AGENDA
TECHNICAL REVIEW COMMITTEE
AUGUST 7, 2018
10:00AM

WESTMINSTER PINE RIDGE ROADWAY & UTILITY DEVELOPMENT CONSTRUCTION PLANS CITY OF FRUITLAND PARK, FLORIDA

**CITY OF FRUITLAND PARK
STAFF REPORT BY LPG URBAN & REGIONAL PLANNERS, INC.**

F.E.G. PROJECT NO. 16-043
SHEET NO. C-3
SHEET 3 OF 18

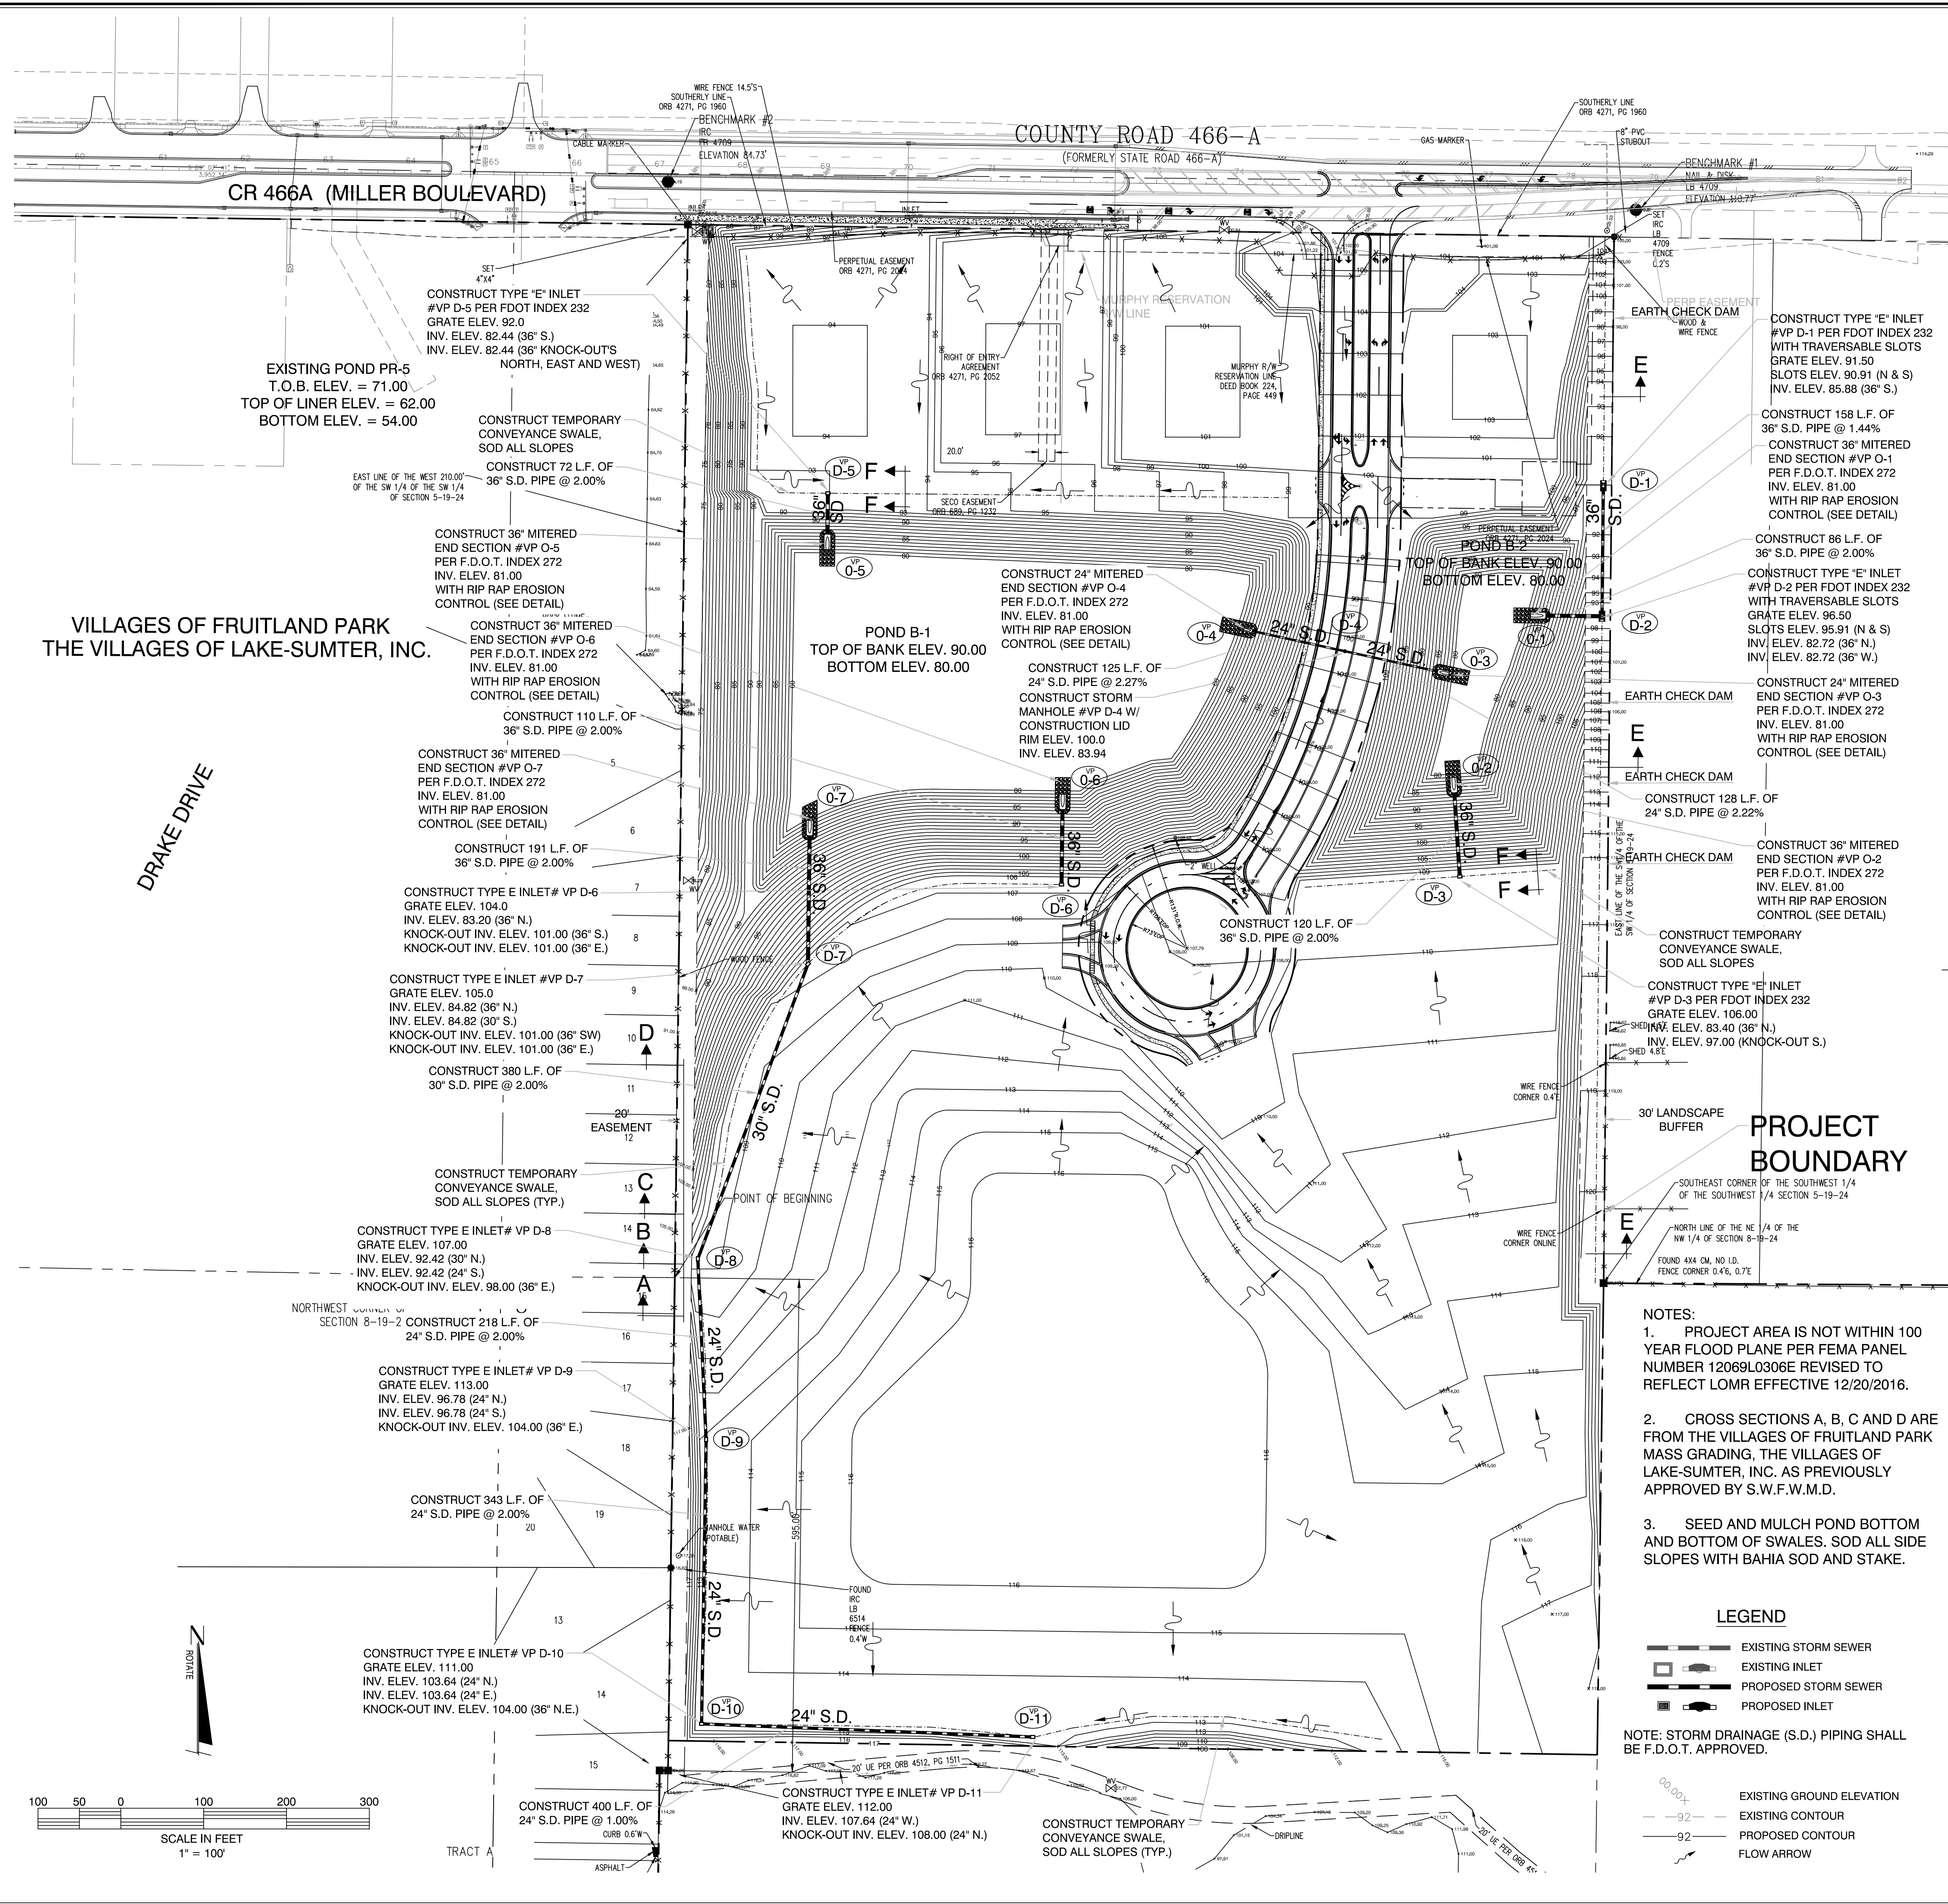
3. Cover Sheet – The cover sheet lists sheet C-3 as a survey. Sheet C-3 appears to be a “permitted conditions” plan based on the approved mass grading permit. Please modify cover sheet accordingly.

4. Sheet C-3 – The elevations listed for Pond PR-5 adjacent to the site are listed in The Villages Datum. Please revise to NAVD88.
5. Sheet C-3 – The sheet is labeled as existing grading and drainage, but includes many callouts to construct inlets, pipes, etc. Additionally, the proposed roadway is shown as existing and the hatching is missing for the areas to be seeded and the areas to be sodded. The sheet was also not signed and sealed. To help clarify the intent of this sheet, remove the proposed roadway and add the following note: “This plan sheet represents the permitted mass grading condition of the site based on the permit issued to the First Baptist Church of Leesburg, Inc. and signed by the City Manager on March 27th, 2018. It is provided for informational purposes.”

PROJECT NO. 16-043
SCALE 1" = 40'
DATE AUGUST 2017
SHEET NO. C-9
SHEET 9 OF 18

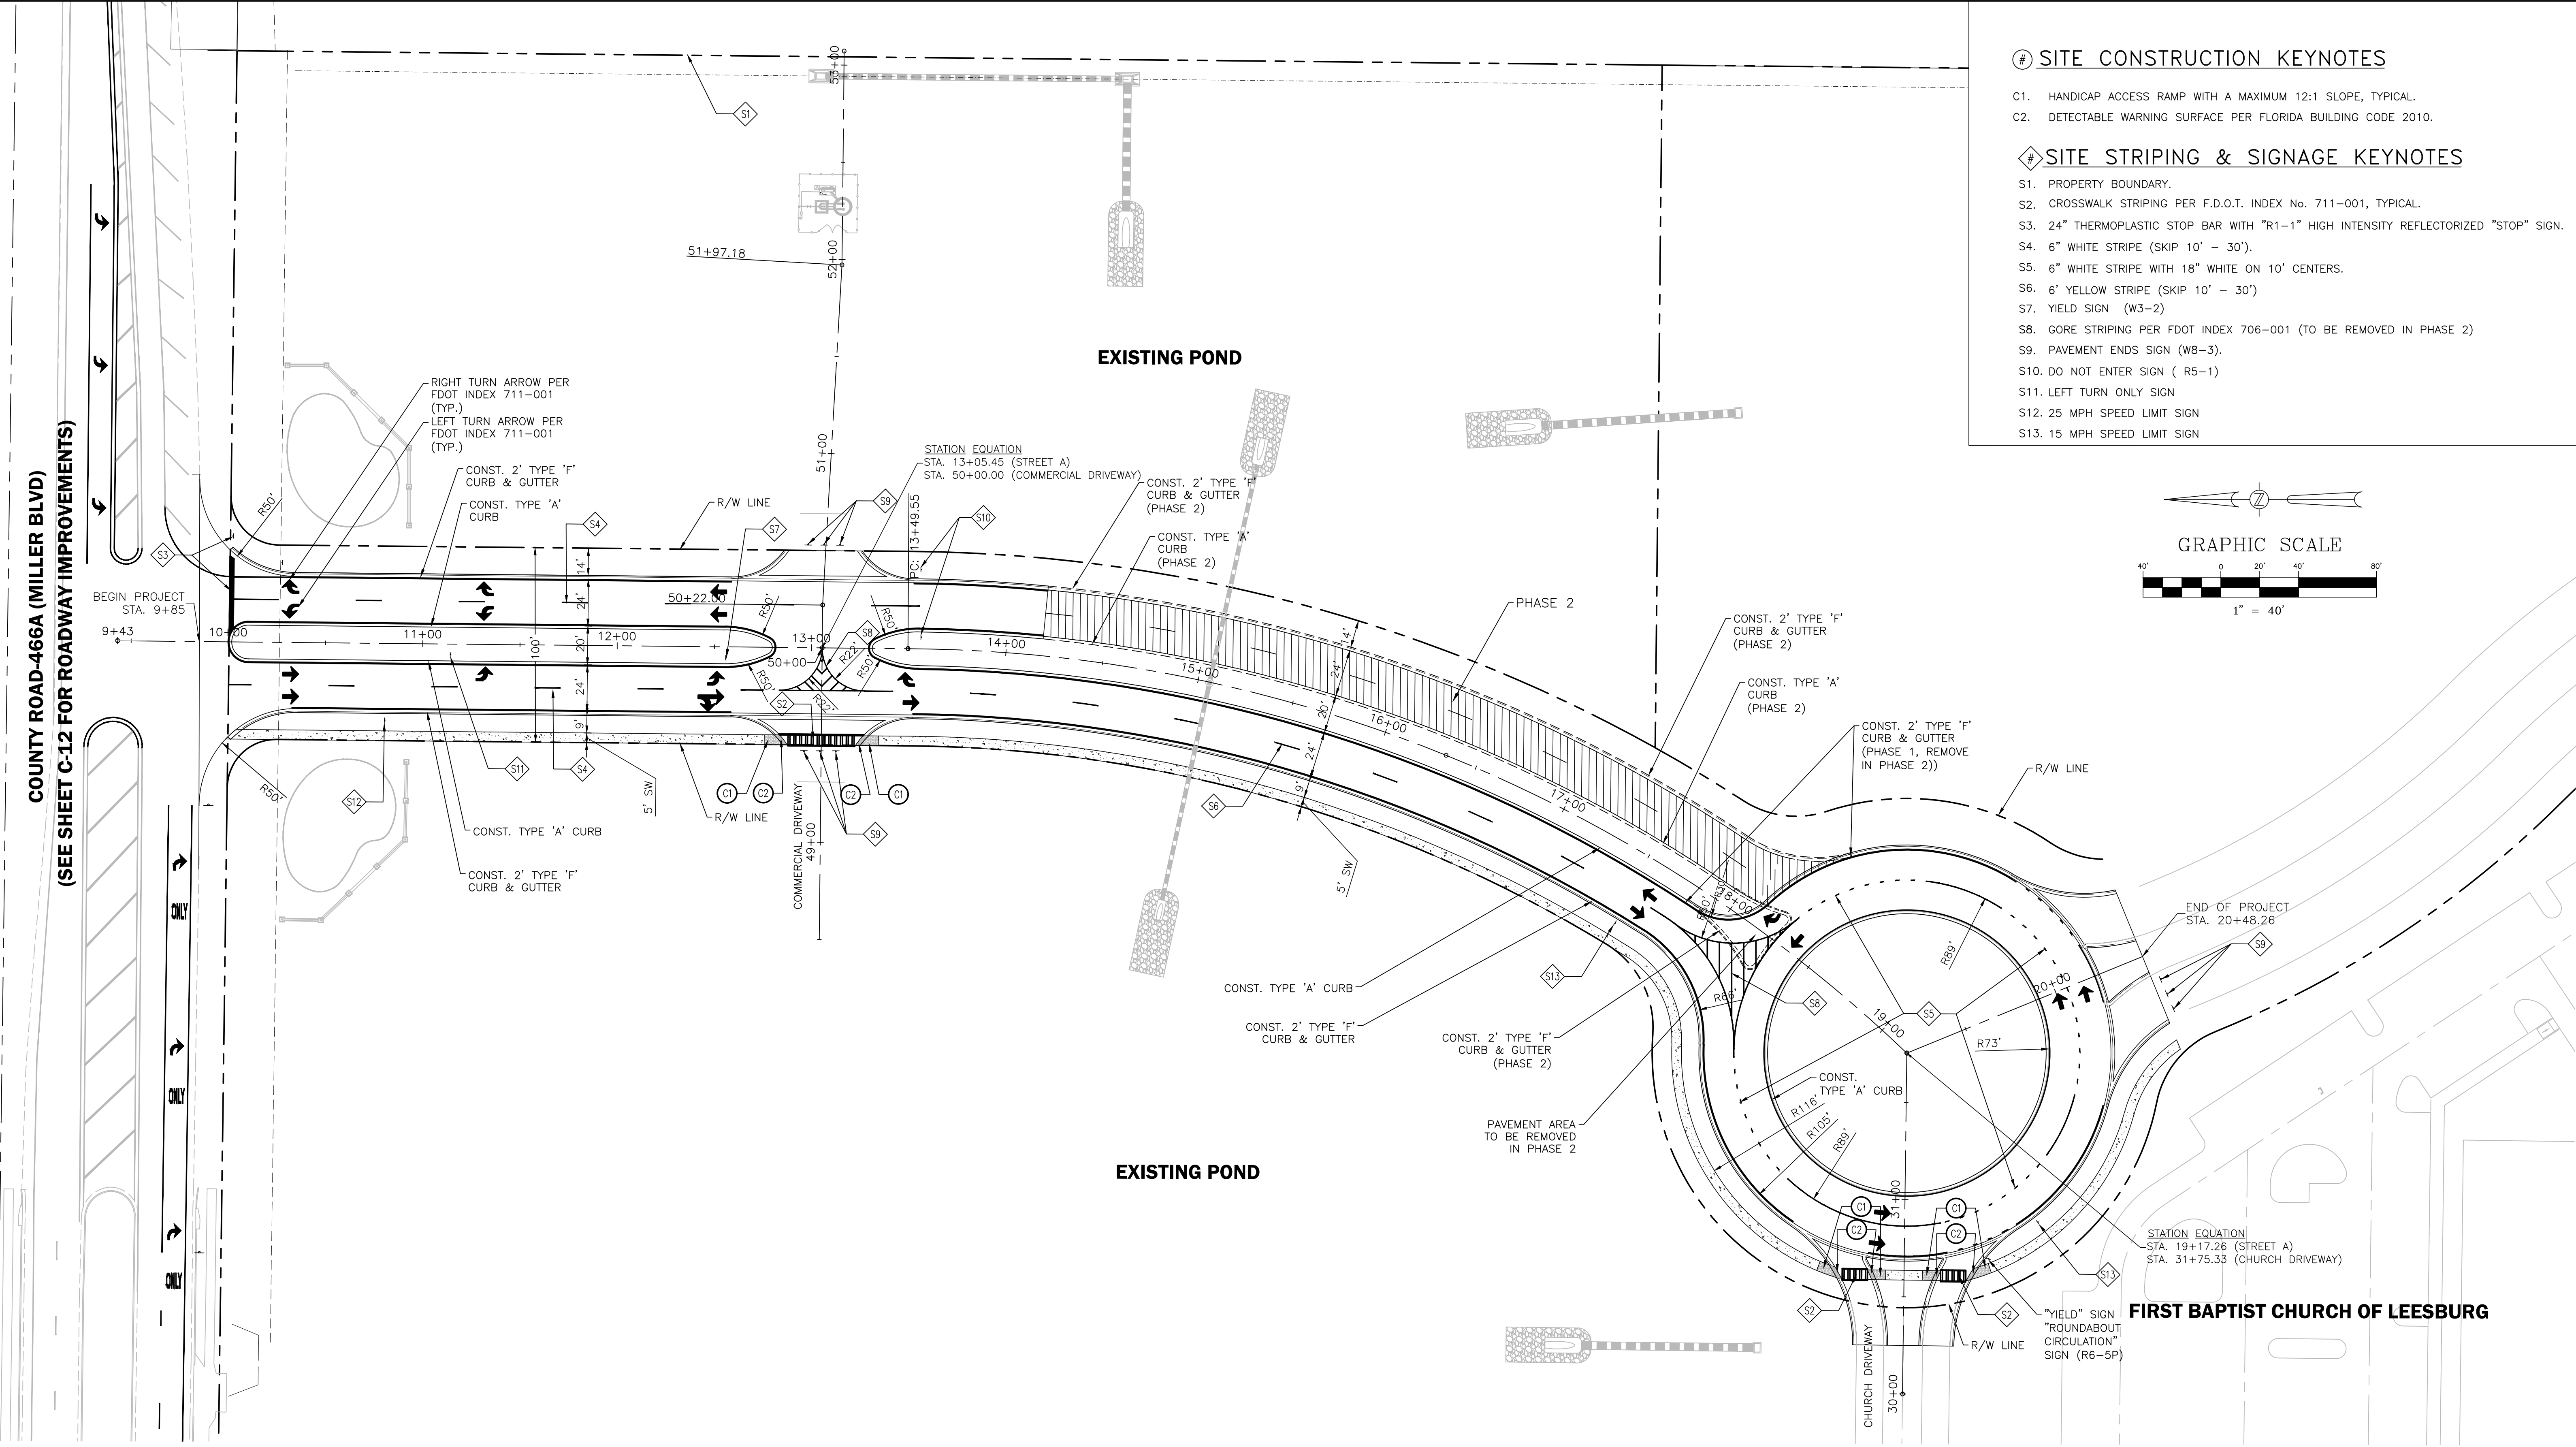
6. Sheet C-9 – At the roundabout, label the lane width and the total pavement width.
7. Sheet C-9 – At the roundabout, label the curb type at the drive aisle intersections.
